# **ADDENDUM NO. 2**

## **RIVERWALK WEST FINAL PHASE**

**BID #26-012**

**ISSUED: May 14, 2026**

**RIVERWALK DETAIL - POROUS PAVEMENT**  
NOT TO SCALE

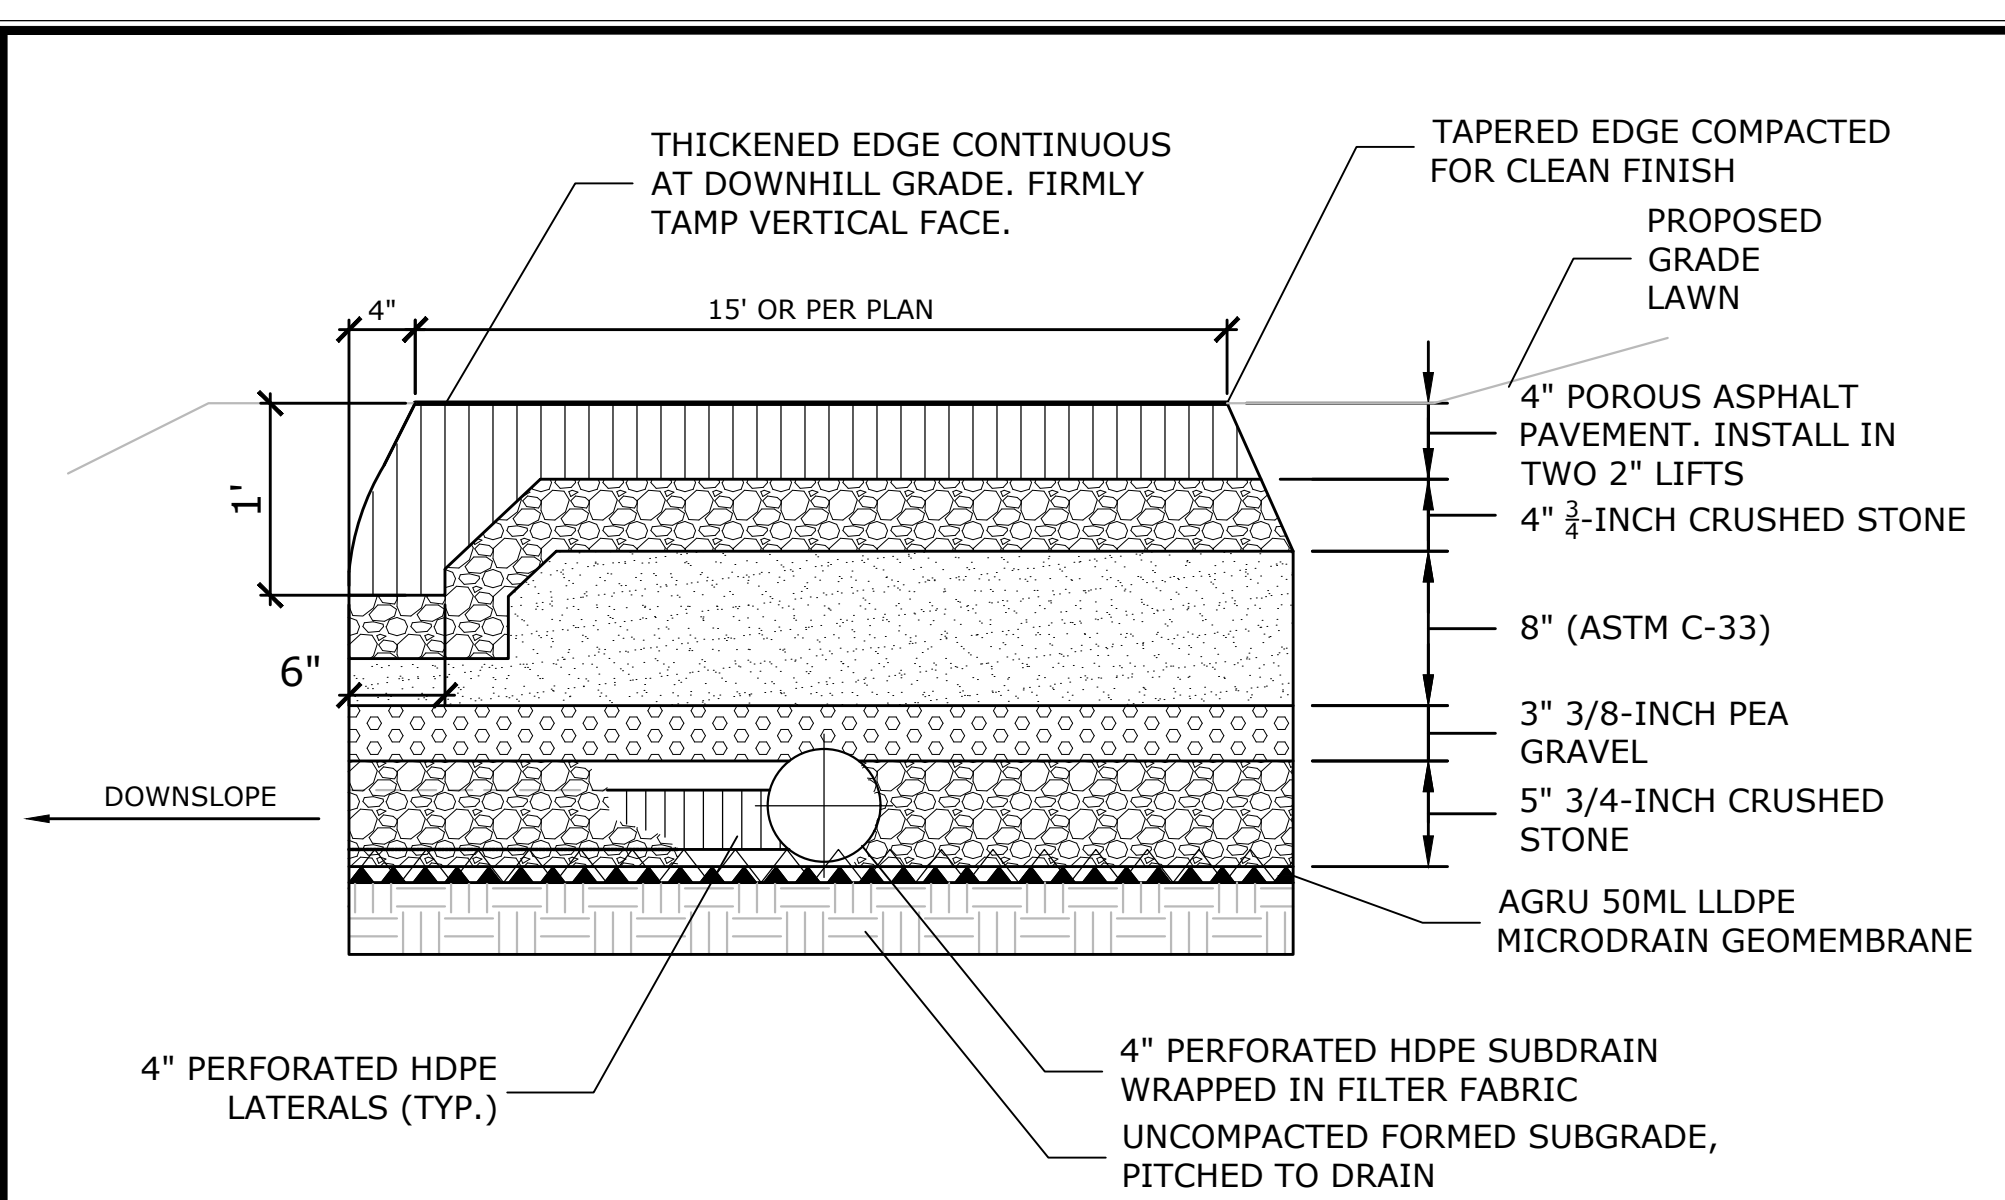
**Q13: Riverwalk Detail on sheet SD-1 shows 4" perforated subdrain under porous pavement. Please provide a layout detail of the subdrain on the utilities plan.**

**A13:** Response- Underdrain has been added to sheet GU

**PLACED BOULDER IN PLANTED AREA**

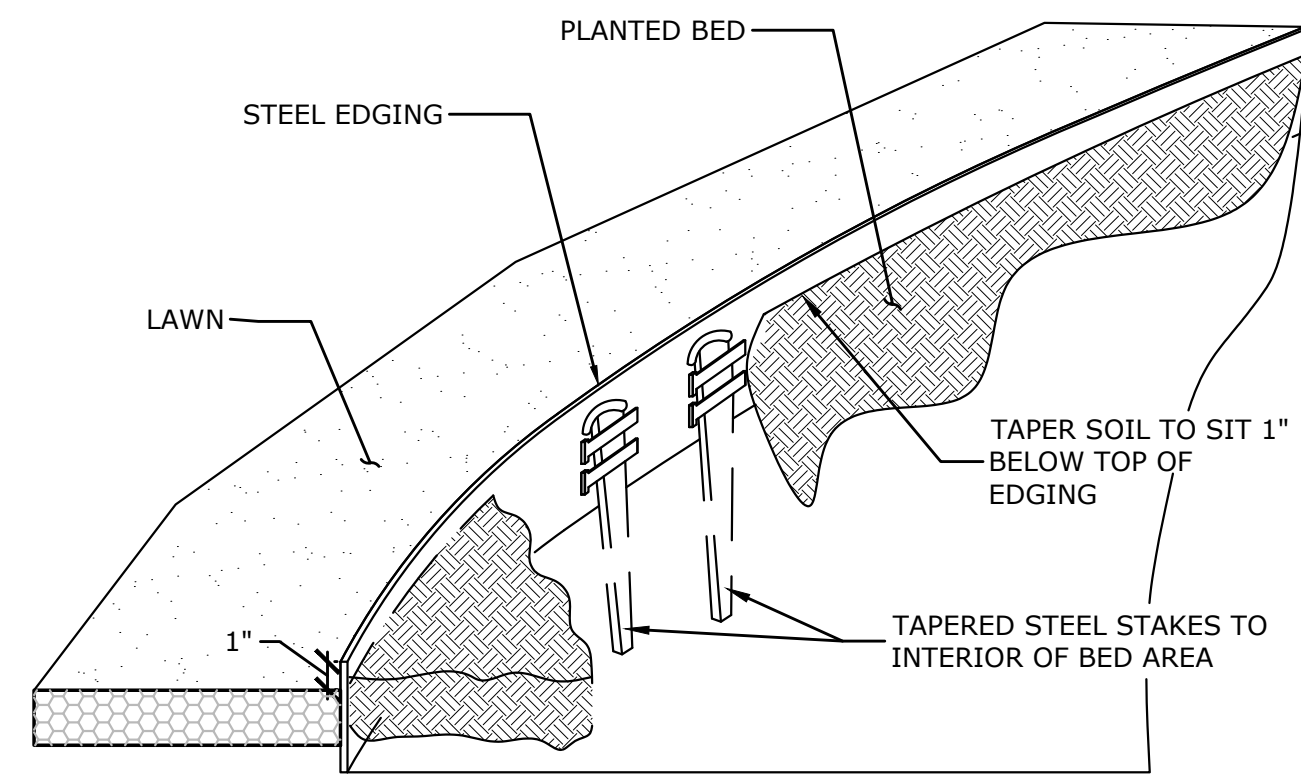
- Q9:** Please clarify the color of the granite seats and cap.
- A9:** Response: For the granite cap, we will inquire with the City for submittal data from the previous Town Landing project for details and provide in the next addenda. For the Granite cut stone seating, the detail has been replaced with a "Placed Boulder" detail to match what was installed at the Stadium Project. See Detail and notes added to Addendum 02 plans.

Response: the Granite cut stone seating has been replaced with a "placed boulder" detail to match what was installed at the Stadium Project. See Detail and notes added to Addendum 02 plans.

**CONCRETE WALL "A" SECTION**  
SCALE: 1/2"=1'-0"

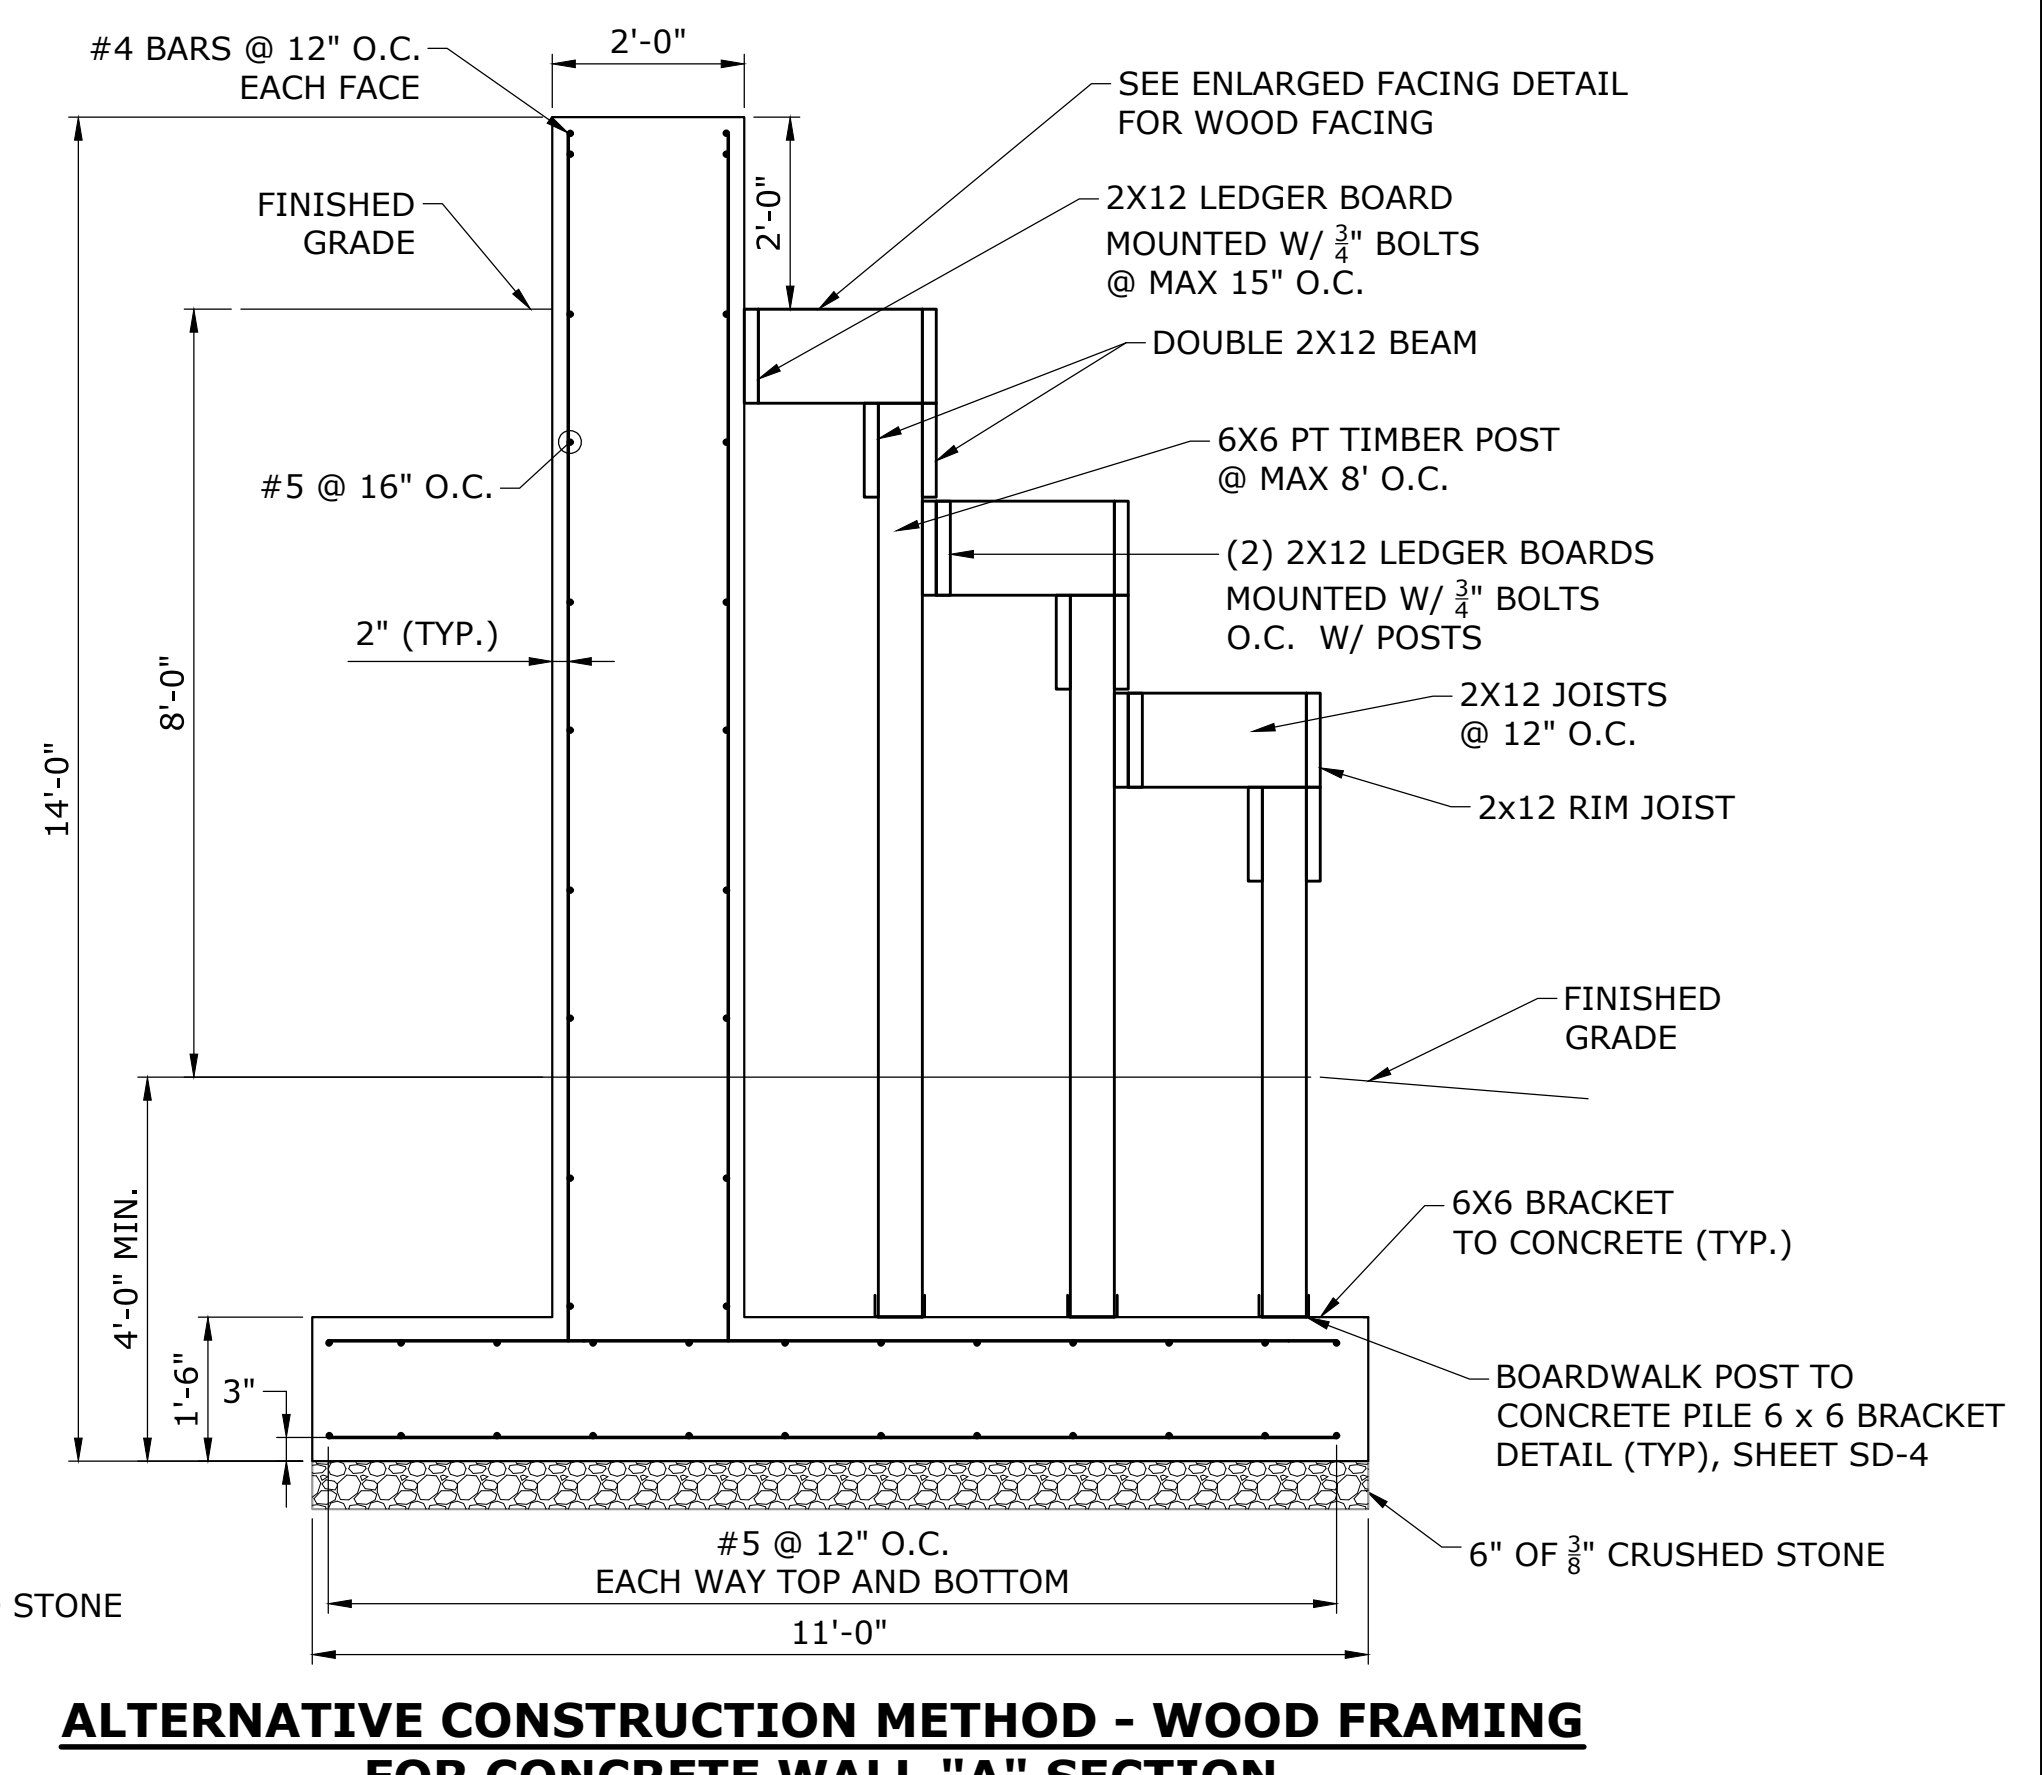
- Q7:** Please clarify if Alternate 3 includes the CIP Wall as detailed on SD-4 and Concrete Wall detailed on sheet SD-3.
- A7:** Response: Yes. concrete wall "A" on SD-3 and the C.I.P wall (between the plaza and adjacent concrete sidewalk) on SD-4 are part of Alternate 3.

**GRANITE CAPSTONE ON SHEET PILE WALL (WALL TYPE 2)**  
SCALE: 1/2" = 1'-0"

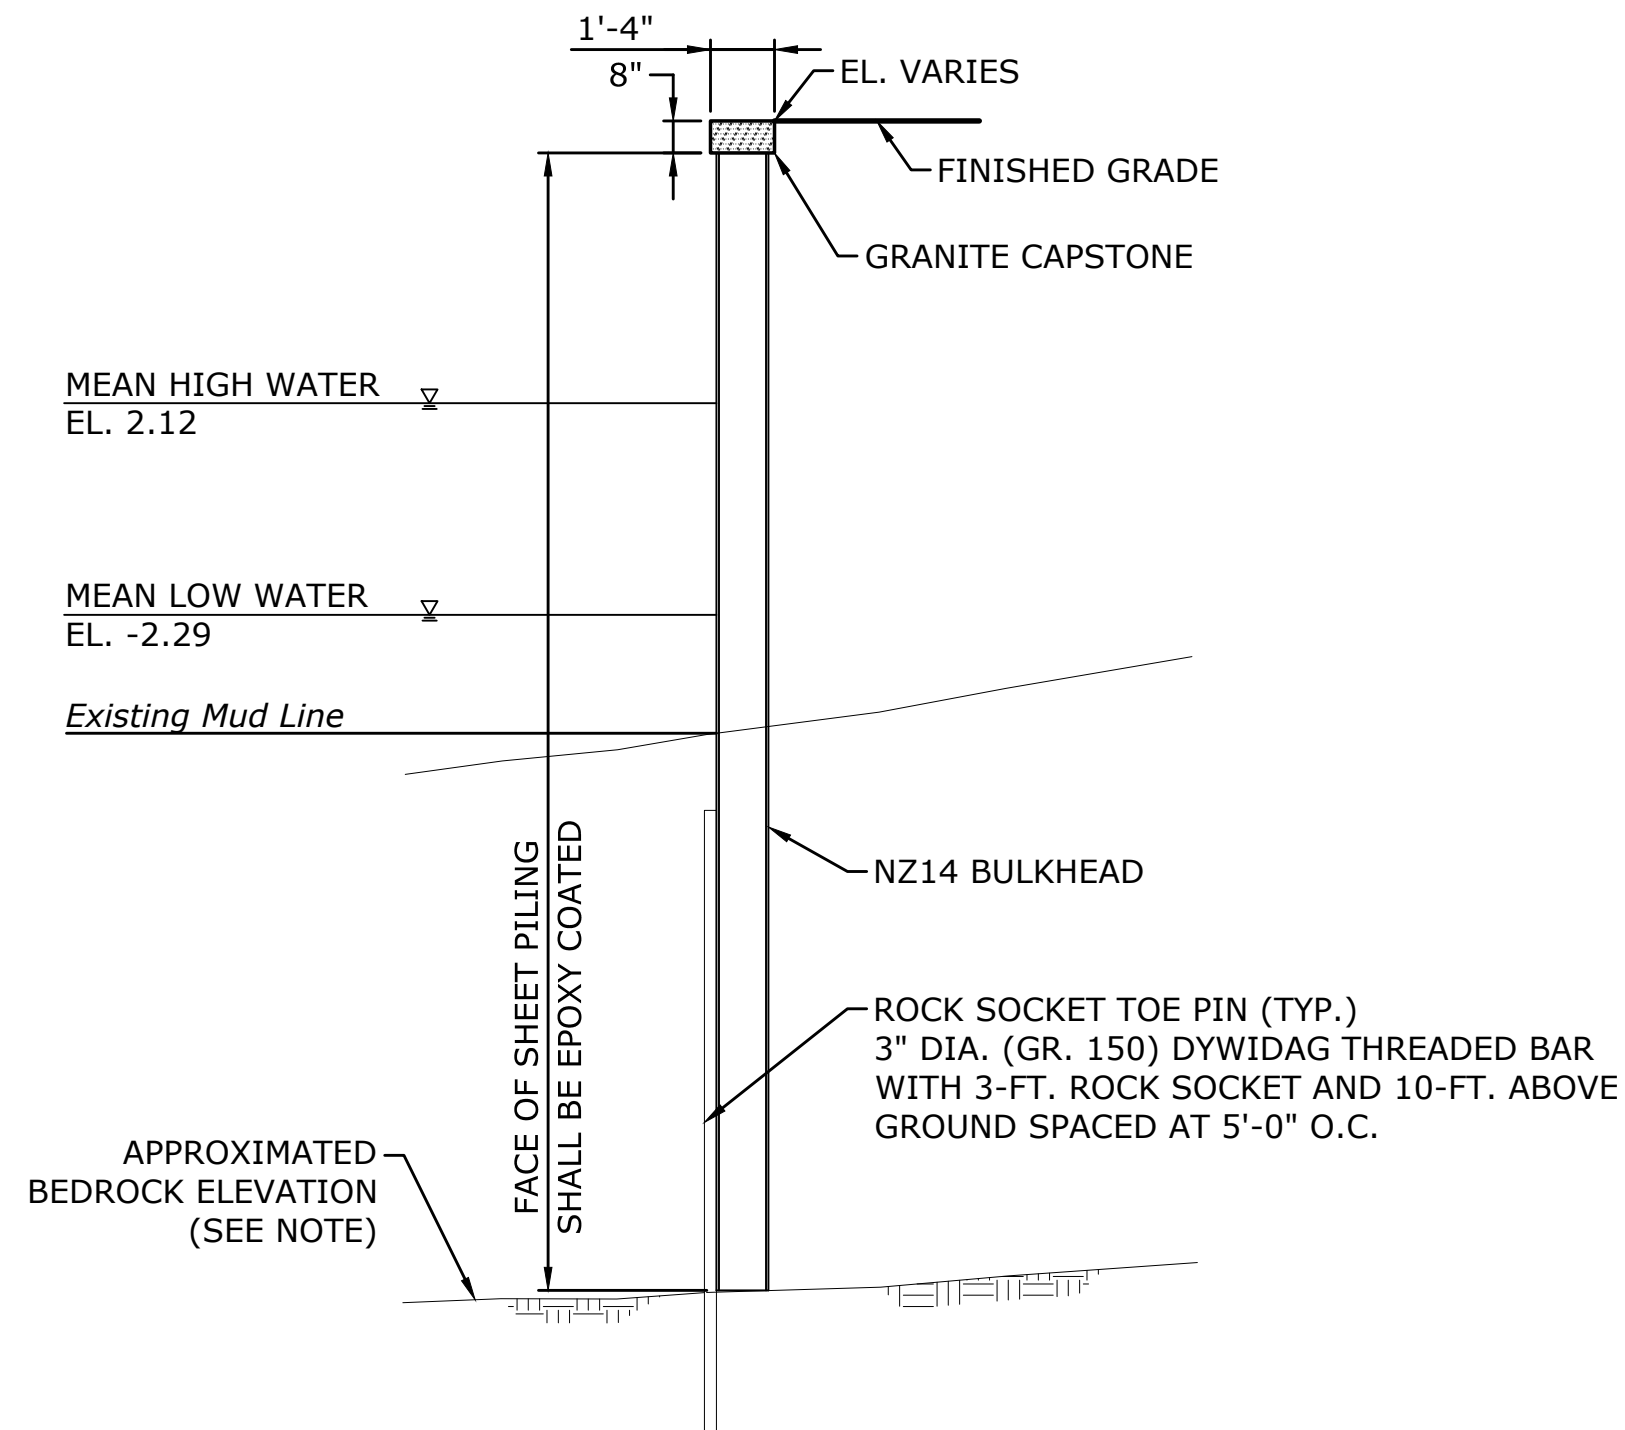
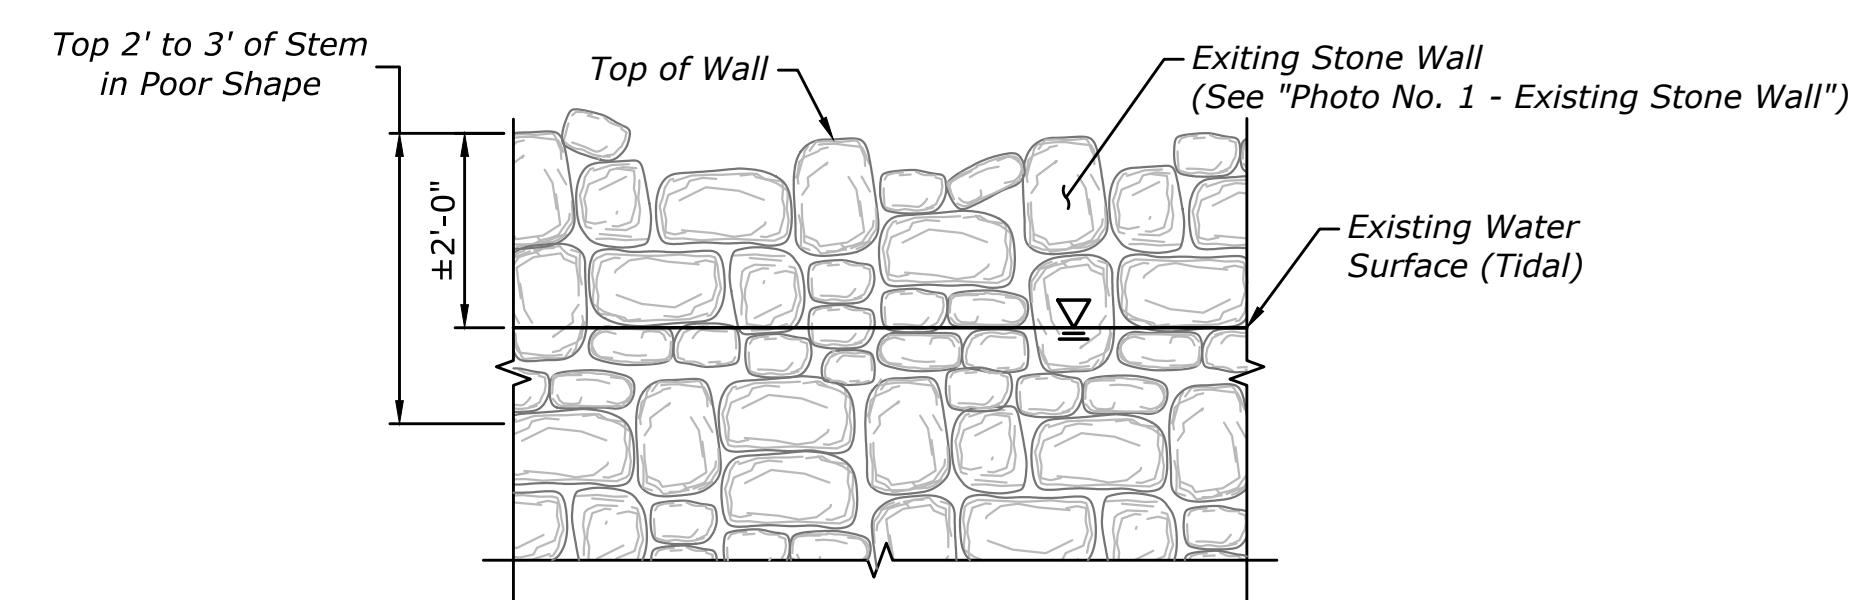
**Q1: Can an equivalent be used for the NZ14 sheeting?**

**A1:** Response: An alternative may be proposed provided the width is appropriate to carry the granite cap. The work is intended to match the adjacent condition.
